Arlington High School Building Committee

Meeting Materials Package – 5/3/2022

Change Order (CO)

Items included in this Change Order:	Cost:
CR 093.1 RFI 216.2 Provide Fire-rated ceiling at Stair 1 for elec conduit.	\$ 4,348.03
CR 189R1 ASI-112-112.1 Misc steel and conc changes Bldg B.	\$ 8,833.05
CR 203R2 ASI-121 Chase wall revisions abutting locker pods Bldg B.	\$ 35,810.78
CR 222 ASI-137-137.1RCP Revs- added GWB soffit at Part E.	\$ 2,045.99
CR 266 CCD-031-ASI-163 provide Spandrel glass in lieu of clear at CW52.	\$ 4,337.64
CR 291 ASI-176 Plywd barrier at catwalk gap between perimeter wall.	\$ 7,408.41
CR 292 ASI-180 Provide milwrk cover of steel box-beam at Aud. Balcony.	\$ 4,903.99
CR 302 Provide steel angle for CW doors/sidelights support at foundation.	\$ 6,435.28
CR 306 Rev to ceiling at Guidance area- added ceiling trim-soffit condition	\$ 3,752.54
CR 320 RFI-392 Rev GWB condition at CW49 for modified CW to wall relationship.	\$ 3,613.26
CR 323.1 RFI-582 Provide Boiler EPO Switches PH 2 areas.	\$ 3,712.59

ARLINGTON HIGH SCHOOL
Massachusetts Avenue, Arlington, Massachusetts
**Revisions to Part B 3rd Floor -
Updated Shear Stud Quantities**

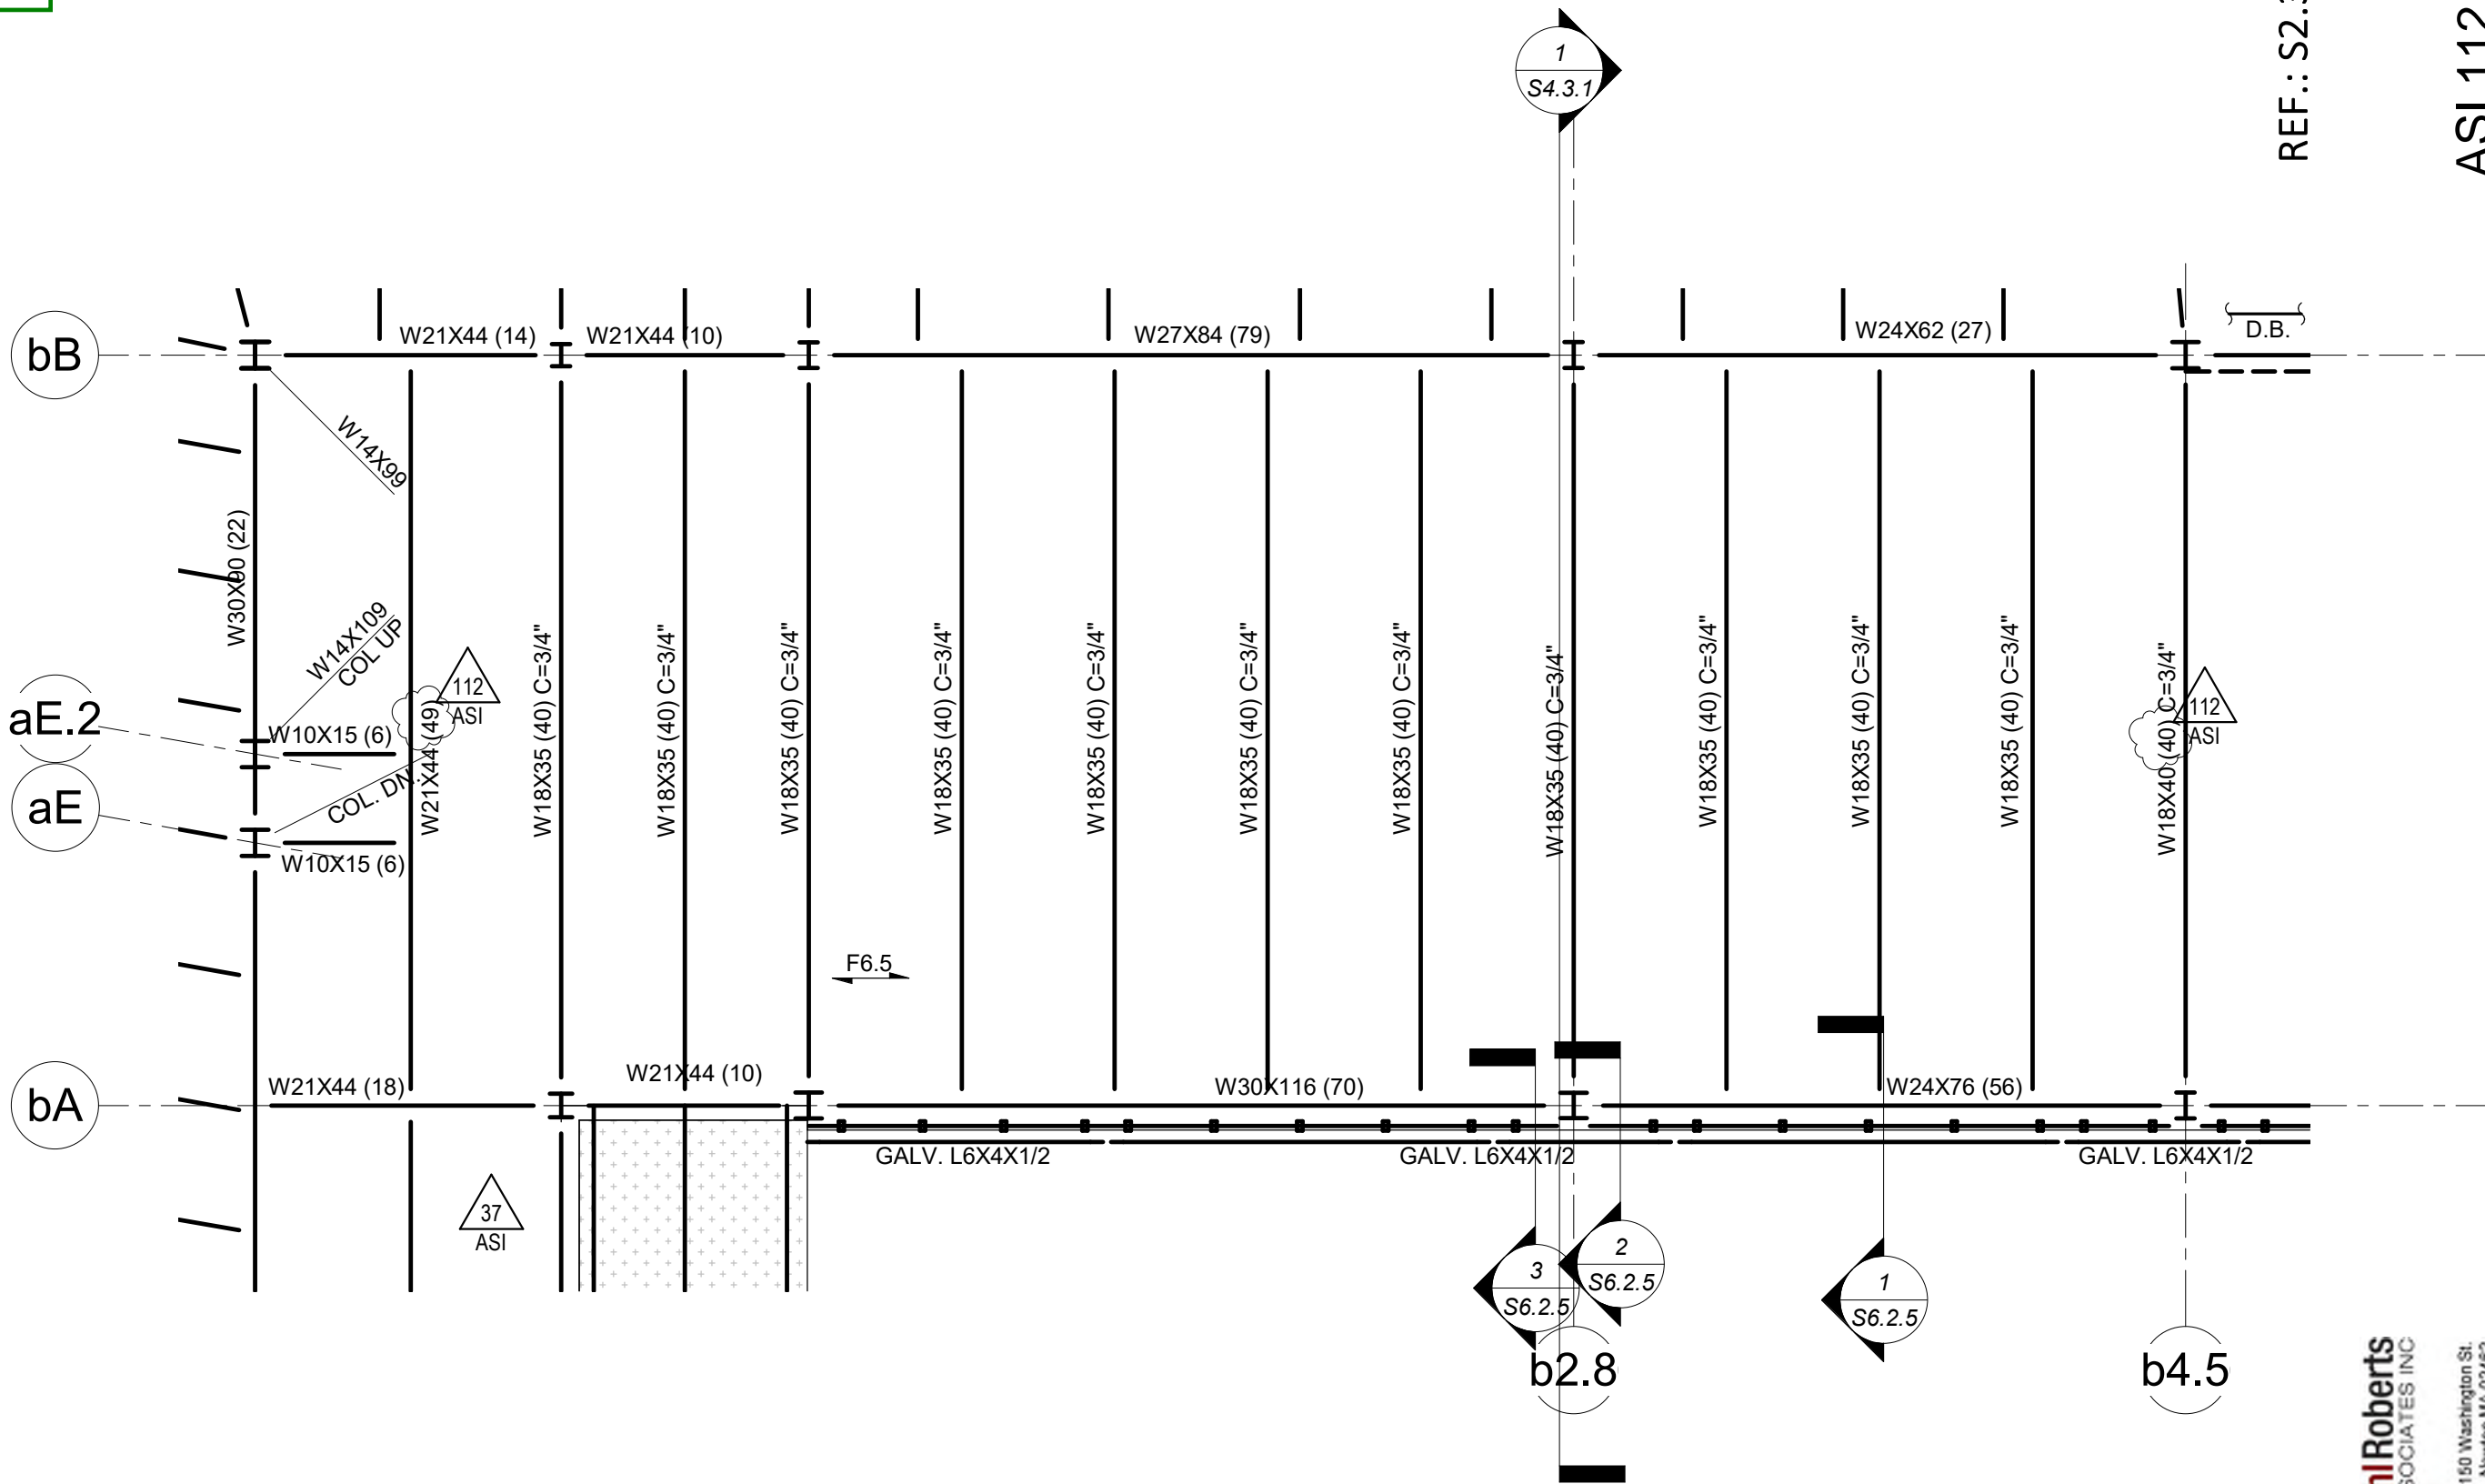
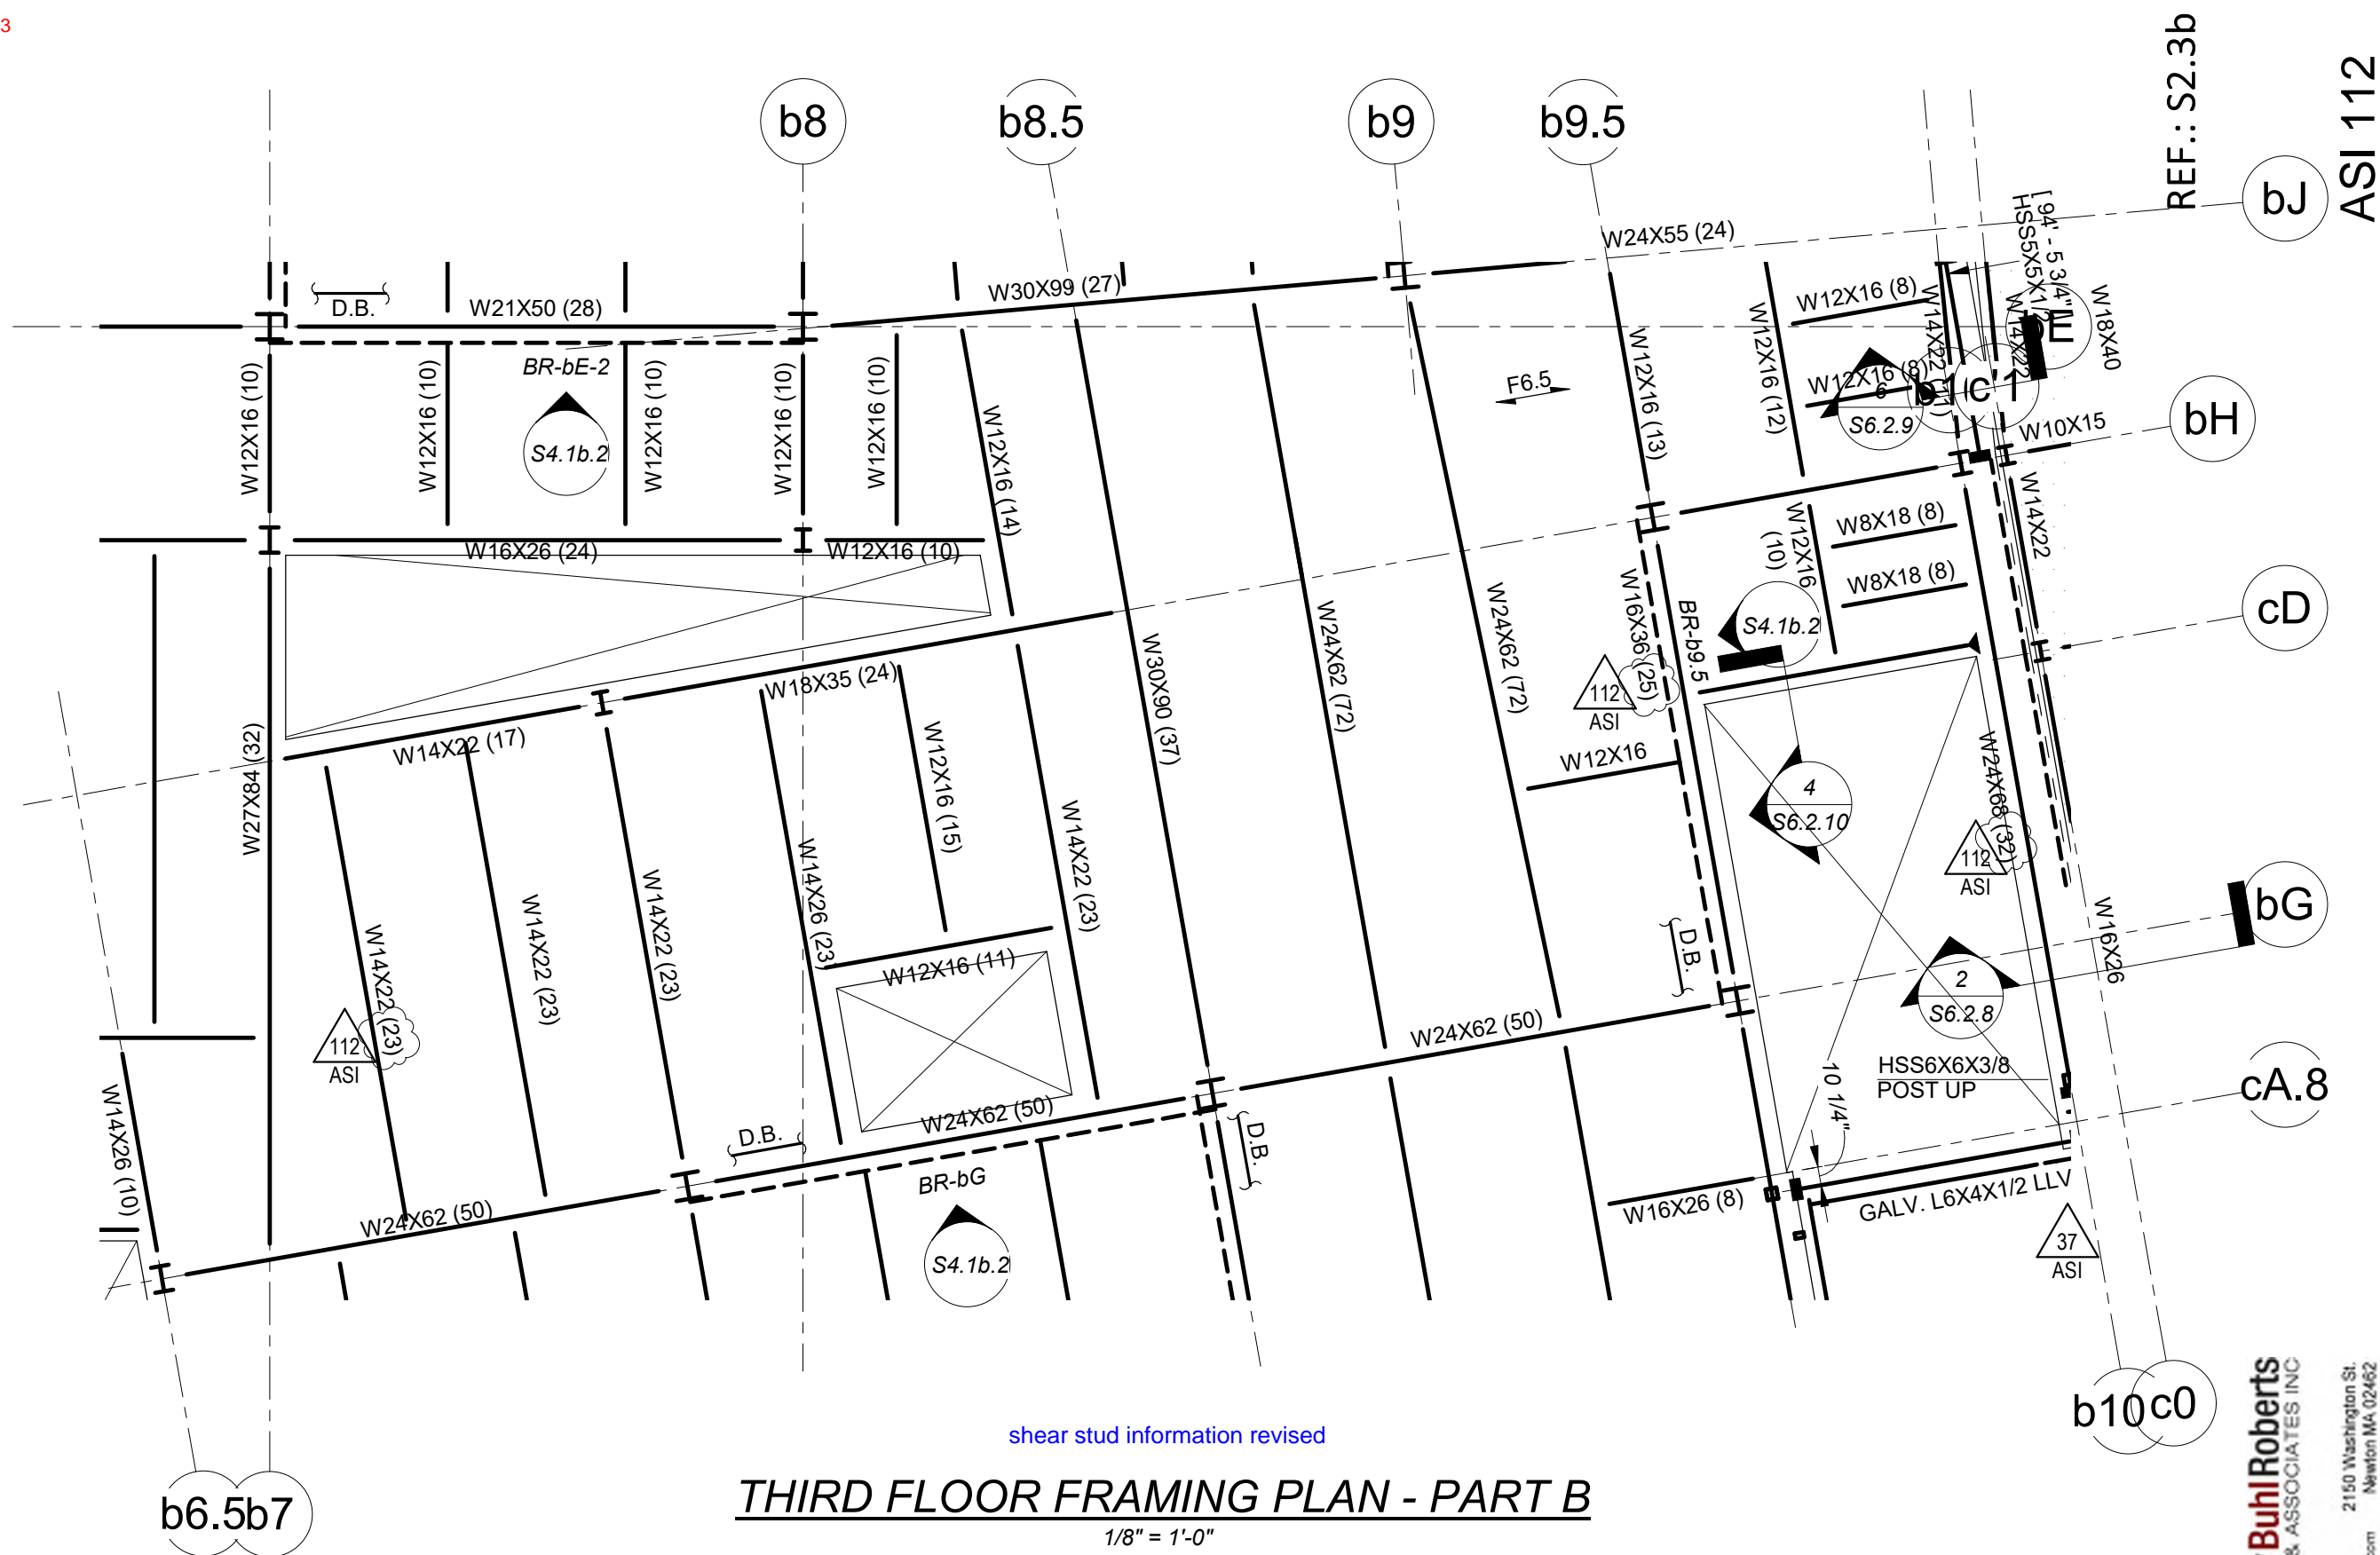
shear stud information revised

ARLINGTON HIGH SCHOOL
Massachusetts Avenue, Arlington, Massachusetts
**Revisions to Part B 4th Floor -
Updated Shear Stud Quantities**

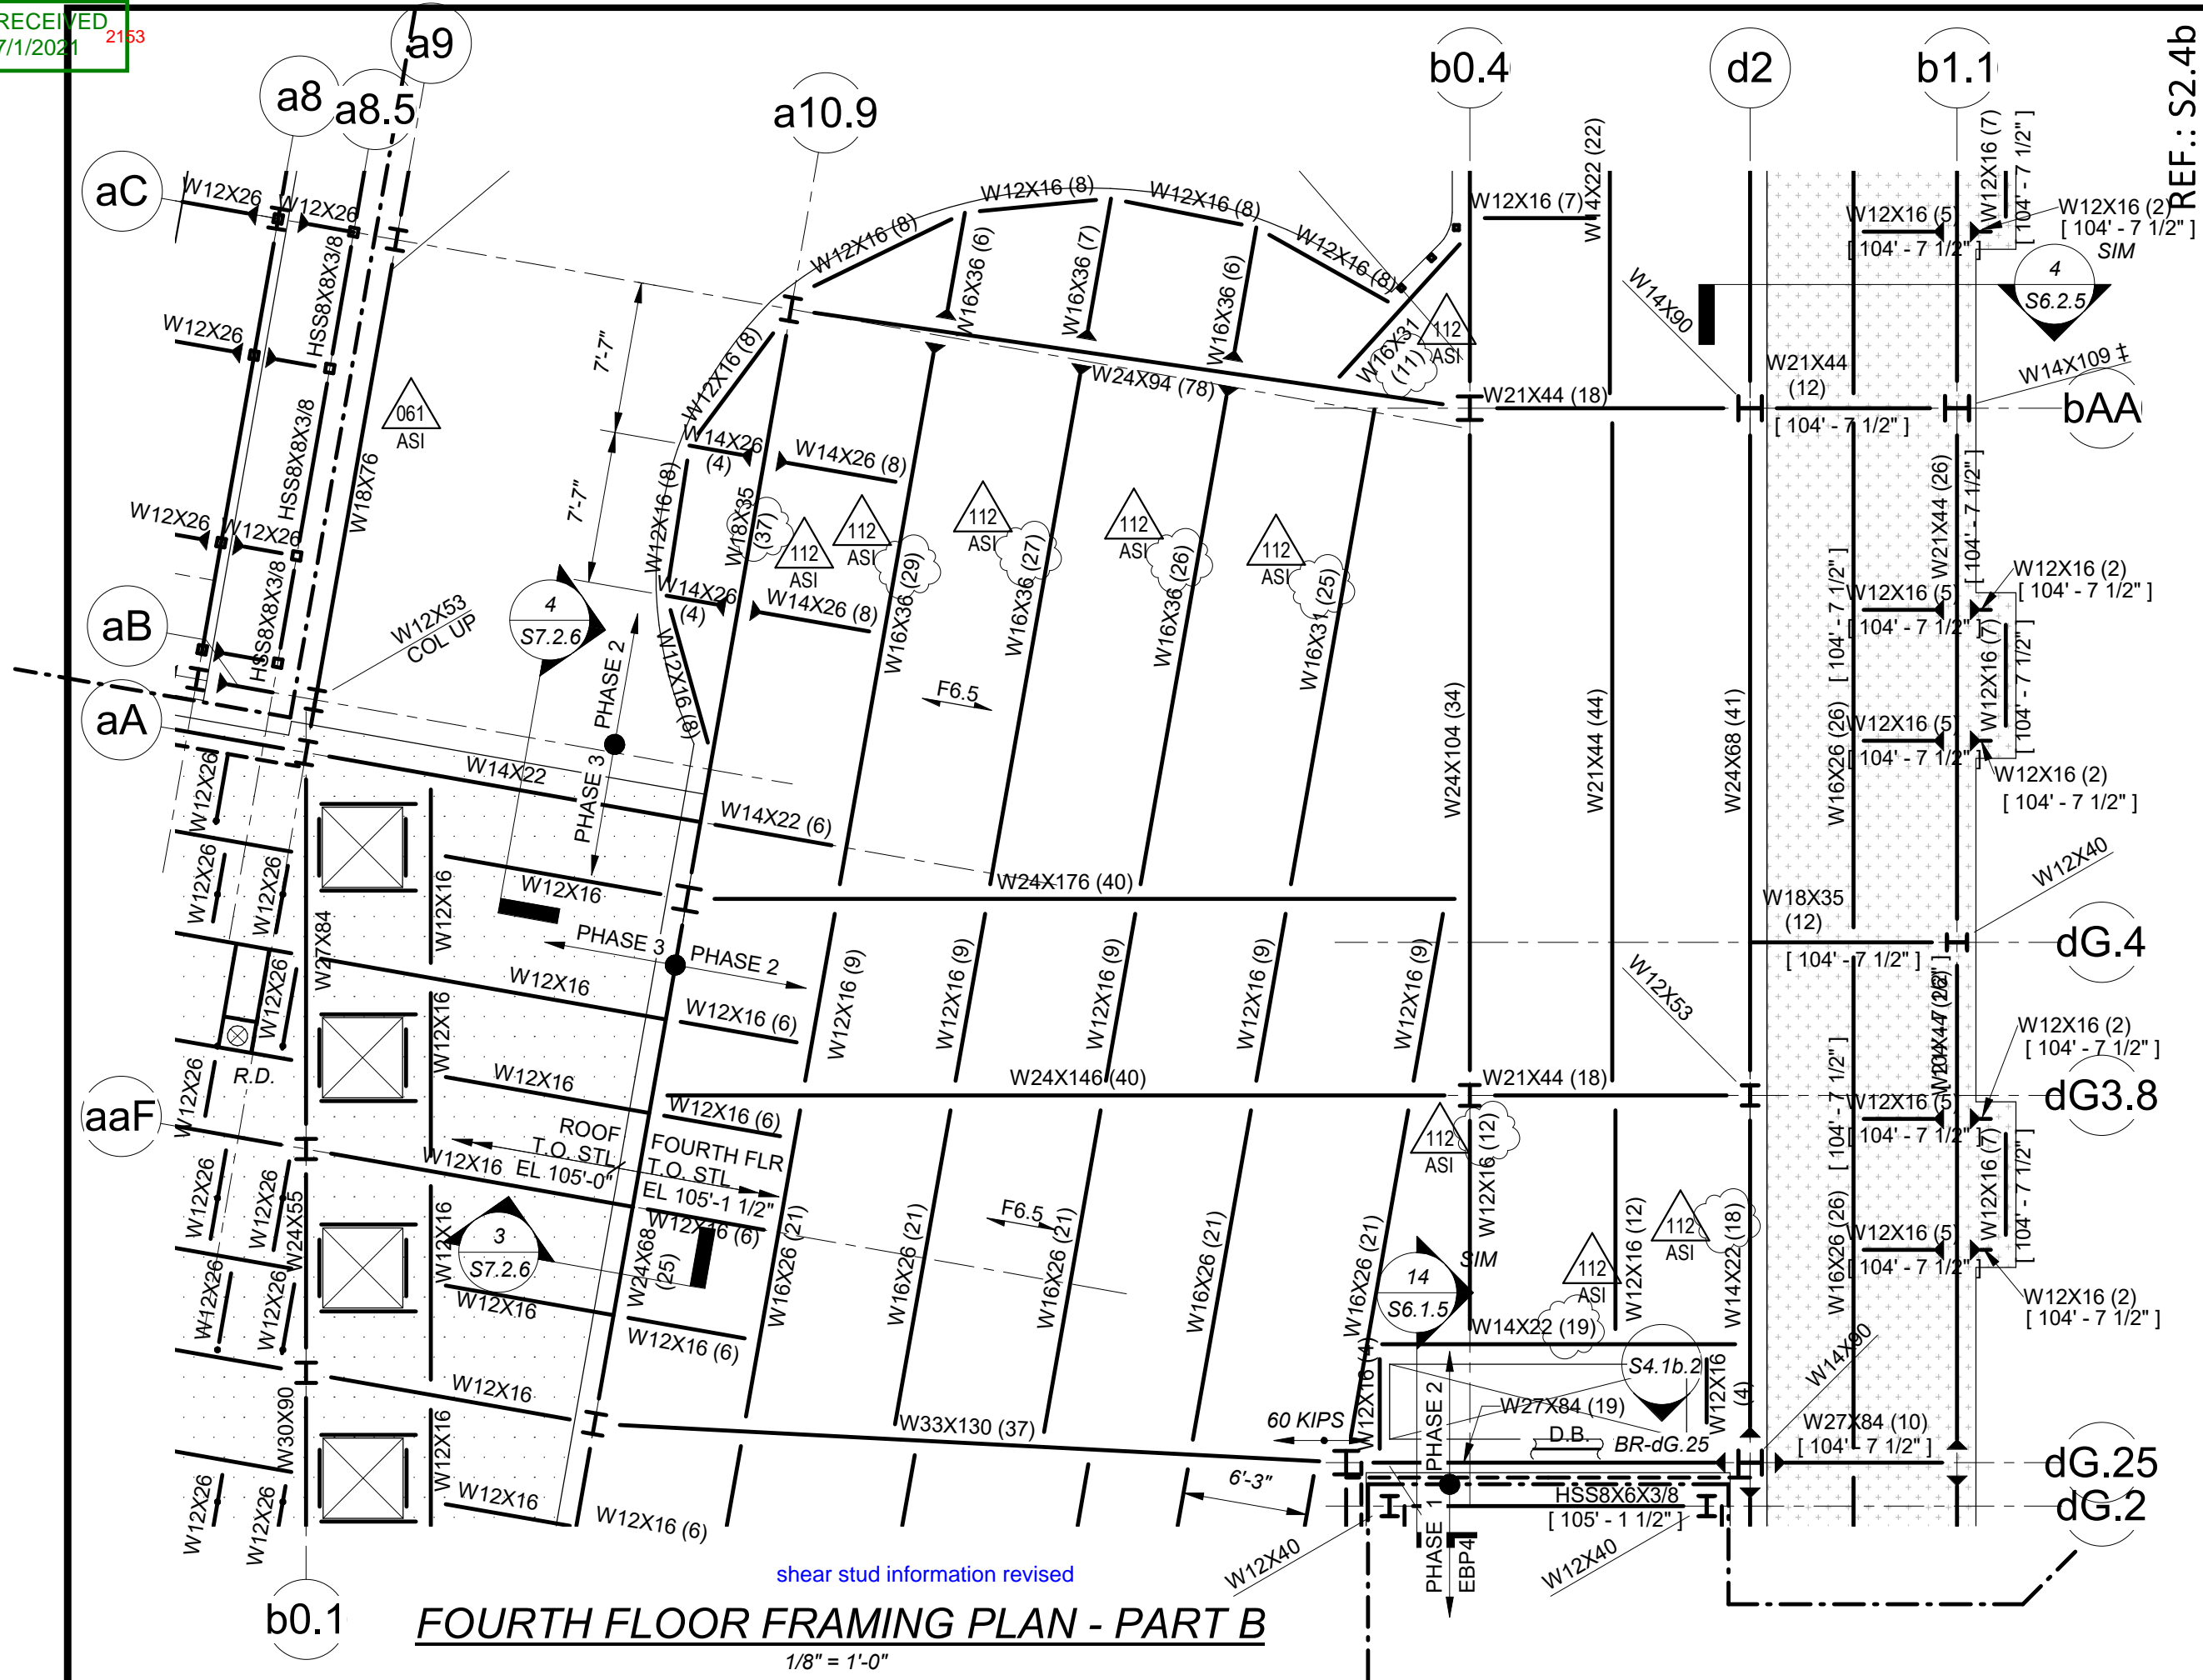
shear stud information revised
